CITY OF ALBUQUERQUE

RE: Manzano High School Gym
12200 Lomas Blvd NE
Request for Certificate of Occupancy – Permanent
Hydrology Final Inspection - Approved
Engineer's Stamp Date 6/8/16 (K22D020)
Certification Dated: 12/17/18

DRAINAGE AND TRANSPORTATION INFORMATION SHEET (REV 6/2018)

CG-101

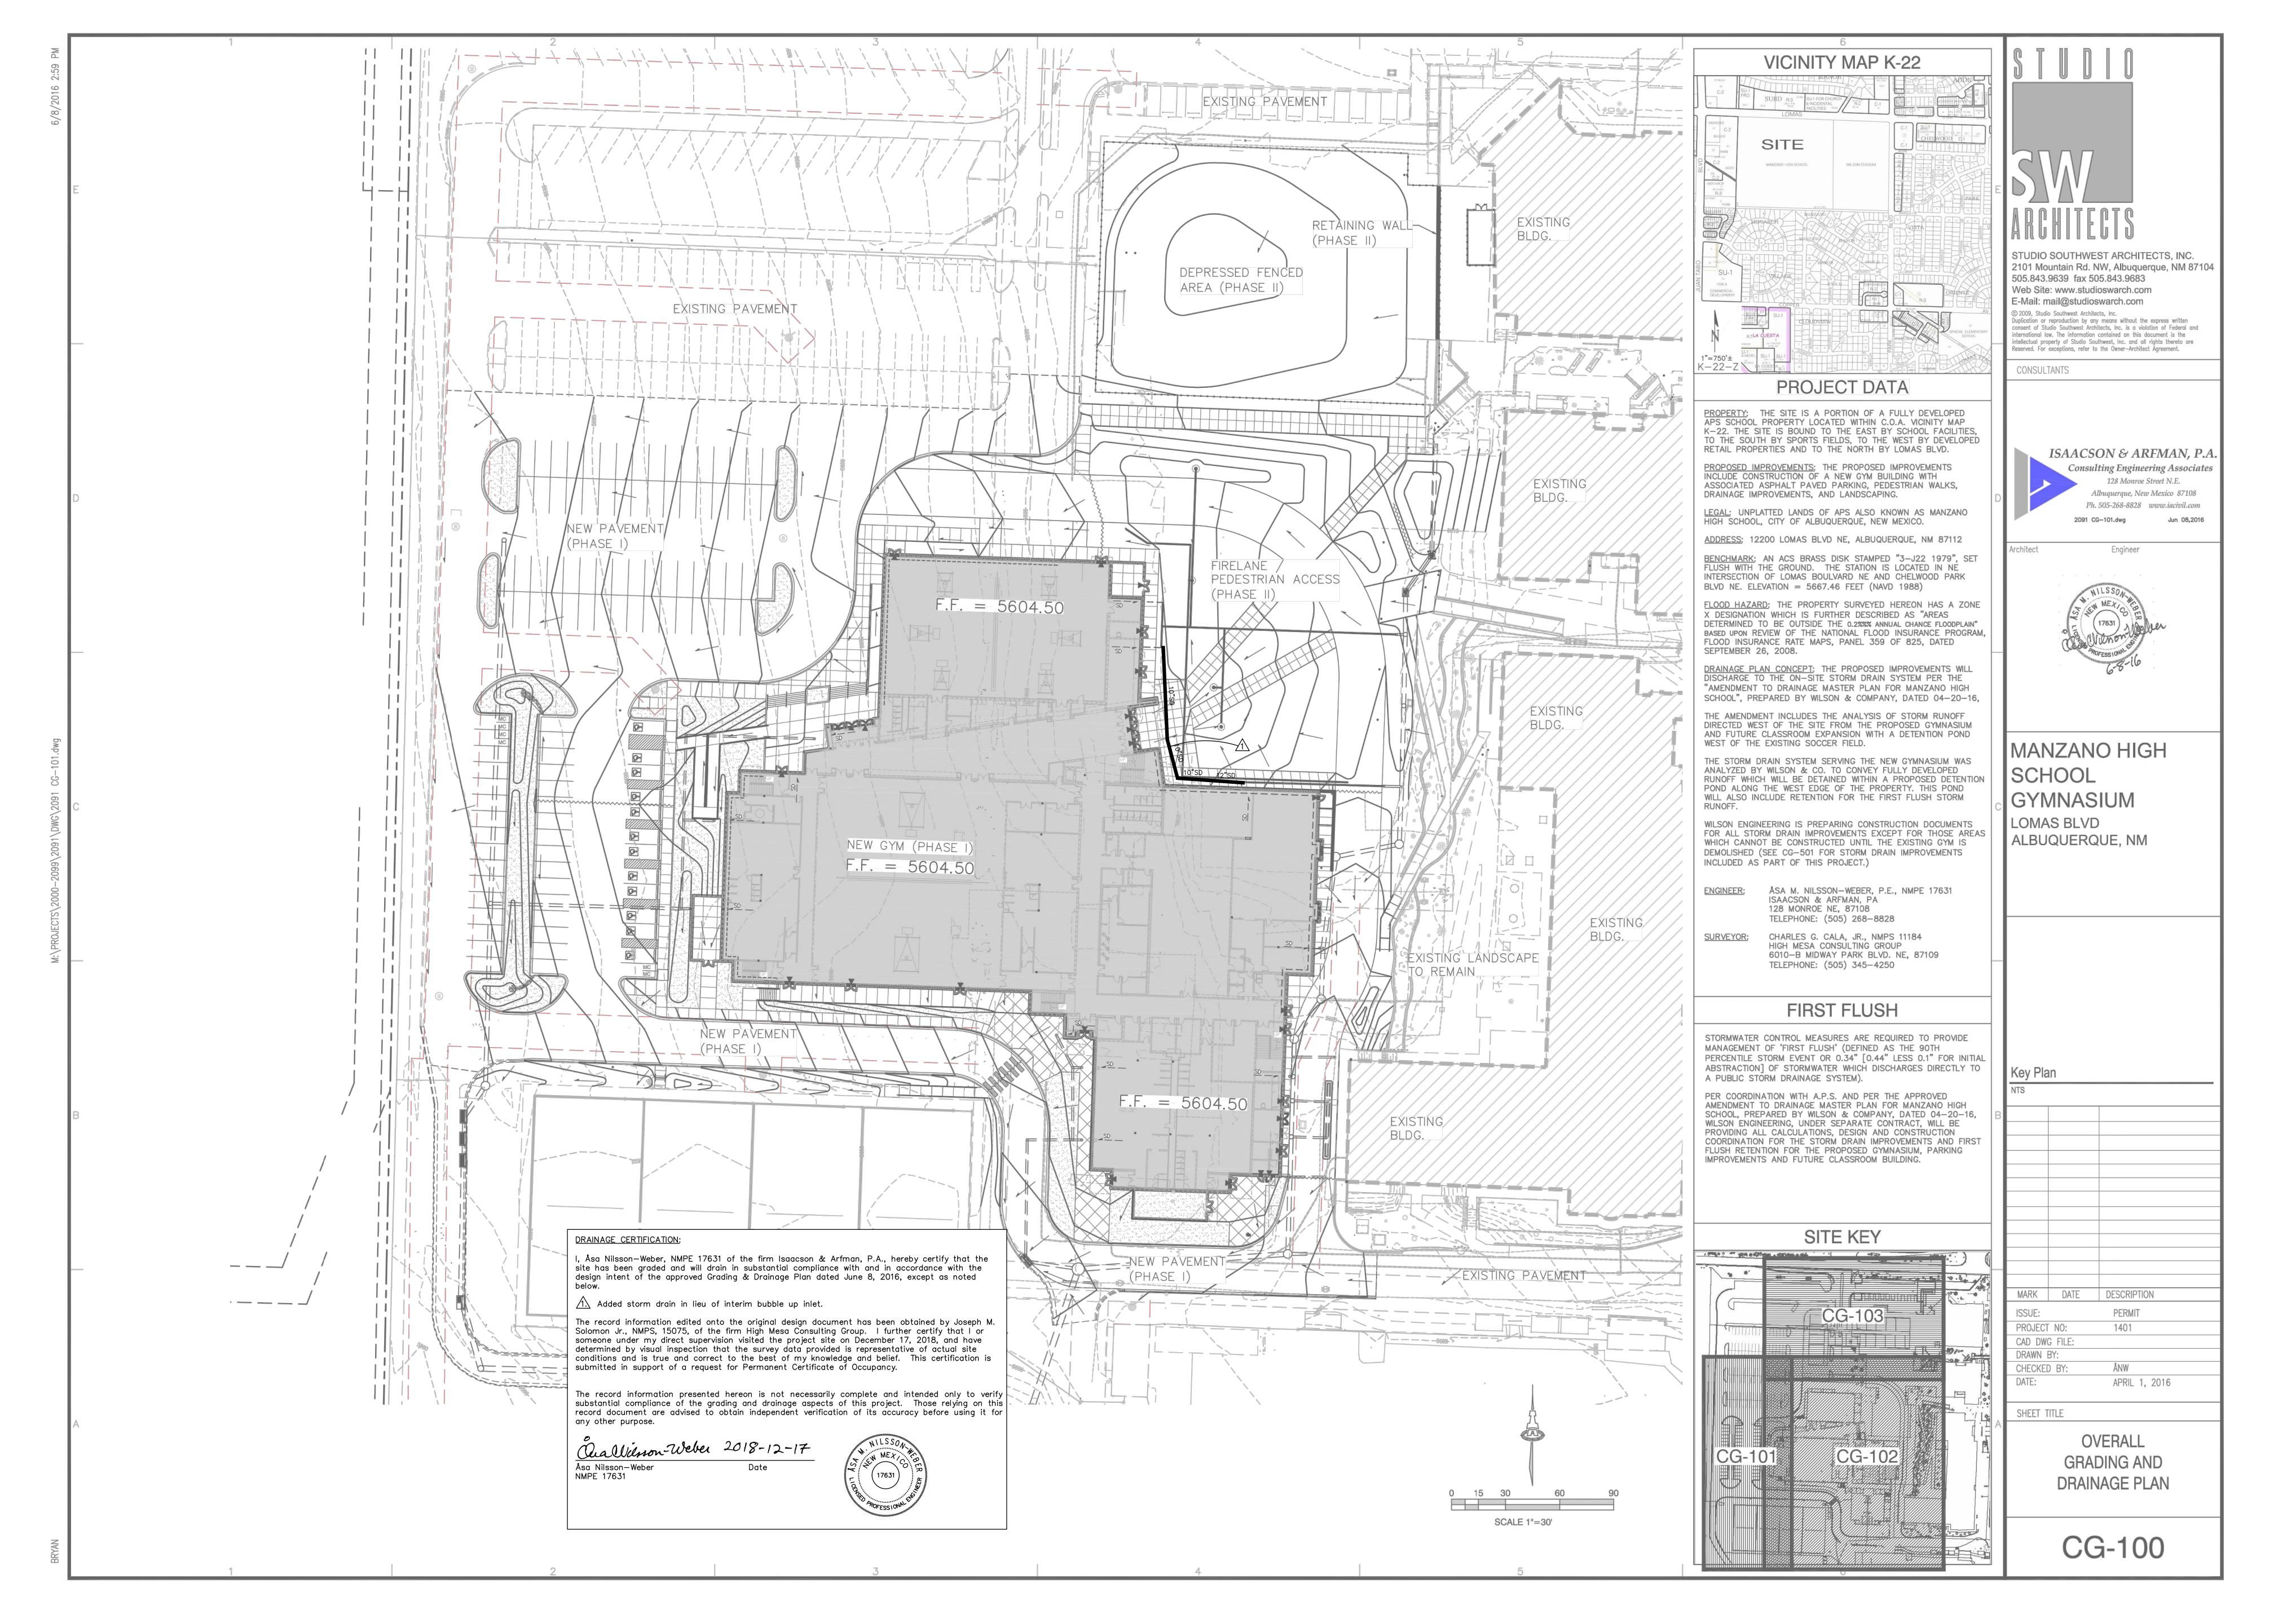
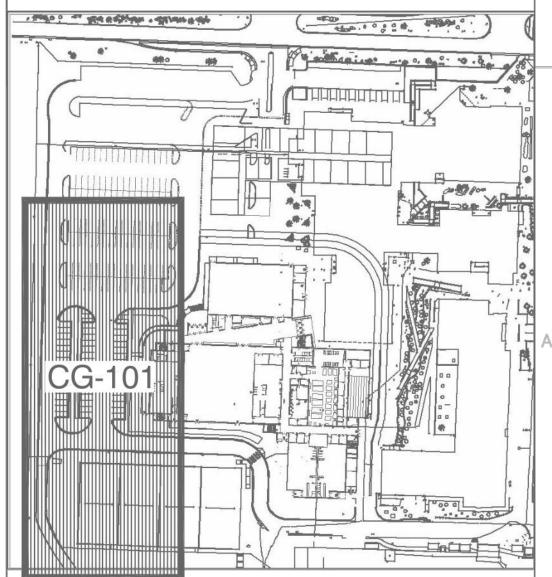
I, Åsa Nilsson—Weber, NMPE 17631 of the firm Isaacson & Arfman, P.A., hereby certify that the site has been graded and will drain in substantial compliance with and in accordance with the design intent of the approved Grading & Drainage Plan dated June 8, 2016, except as noted

1. Added storm drain in lieu of interim bubble up inlet.
